## Memorandum

Subject: Equivalent Level of Safety to 14 CFR Part 23.1545 (b)(4); Pilatus PC-12/47E, Finding No. ACE-07-15

Figure 1 – Examples of airspeed awareness cues on the PC-12E Primus Apex system<sup>1</sup>.

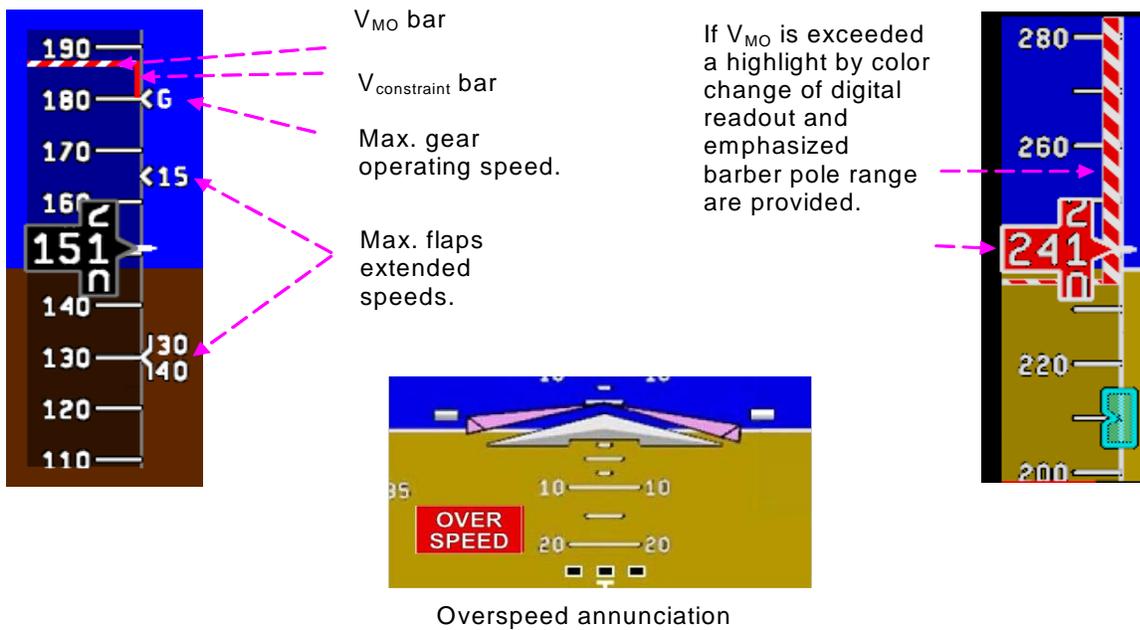
3. The airspeed indicator markings required by 14 CFR, part 23, § 23.1545 are very much written with a round-dial type indicator in mind. Applying these markings to linear tape style airspeed indicators may under some circumstances lead to conflicts with other symbols. On the PC-12E Primus Apex™ system, such a conflict would exist between the Flaps operating range marking required by 14 CFR, part 23, § 23.1545 (b)(4) and the airspeed trend vector, both of which have the appearance of a white bar alongside the airspeed tape.

After an analysis with the PC-12/47E certification team for the Flaps speed range markings on linear vertical Airspeed Indicator, FOCA is of the opinion that the design chosen should be equivalent, or should exceed the intent of 14 CFR, part 23, §1545(b)(4). However, the applicant will have to demonstrate through the Human Factors ground and flight test evaluations planned in the program that this design is effectively equivalent in safety. This means that the awareness of speed, speed dynamic behaviour in relation to the setting of the Flaps is ensured for all phase of flight under adverse flight conditions. FOCA would also make sure that the speed bugs for VR (rotation),  $V_x$  (Best angle of climb),  $V_y$  (Best rate of climb), VAPP (approach), or any other indication do not clutter these primary essential cues.

The FAA is in full agreement with FOCA/EASA position on this issue.

The FAA recommends approval of the applicant's proposal.
